SERVICE INFORMATION

LAND-ROVER PETROL AND DIESEL MODELS

Vol. 2 No. 1

February, 1974

Fig. 1 Additional flywheel timing mark

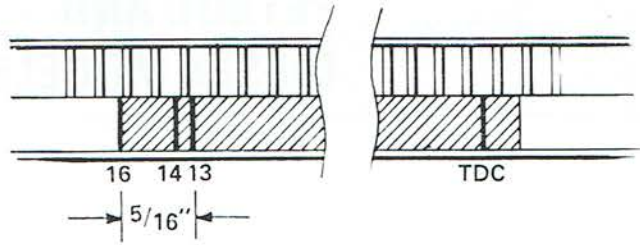
OBJECTIVE: To add 13 degrees timing mark to earlier flywheels.

REMARKS: To conform to the Department of the Environment legal requirements specified in British Standard BF AU 141, re certification of diesel engines for horse power rating and smoke level, the fuel injection timing has been changed from 14 deg BTDC to 13 BTDC. Timing marks on the latest flywheels have been modified accordingly to read 13/14 deg. In the case of stocks of earlier replacement flywheels, which are marked 14/16 deg a 13 deg mark should be added prior to fitting. The illustration shows a practical way of locating the position.

A —13 deg position measured peripherally from 16 deg mark
